Service Bulletin

Bulletin No.: PI0965A

Subject: Squeaking/Creaking Type Noise Heard When Using Clutch Pedal

Models: 2012-2013 Chevrolet Cruze Equipped with Manual Transmission (RPOs MF3, MR5, MZ0)
2012-2013 Chevrolet Sonic Equipped with Manual Transmission (RPOs MZ4, M26)

3412540

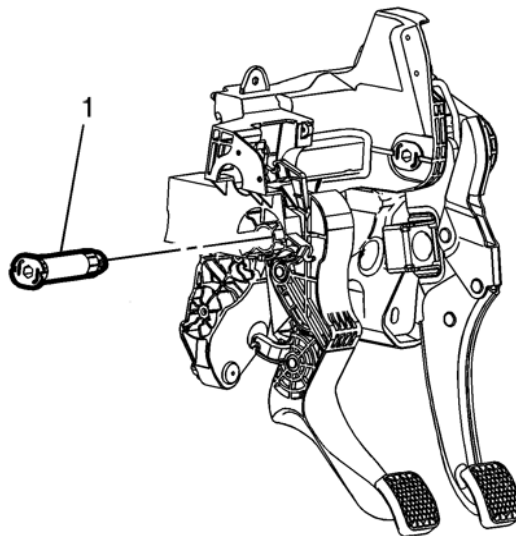
This may be caused from lack of or no lubrication on the clutch pedal pin (1) shown in the illustration above.
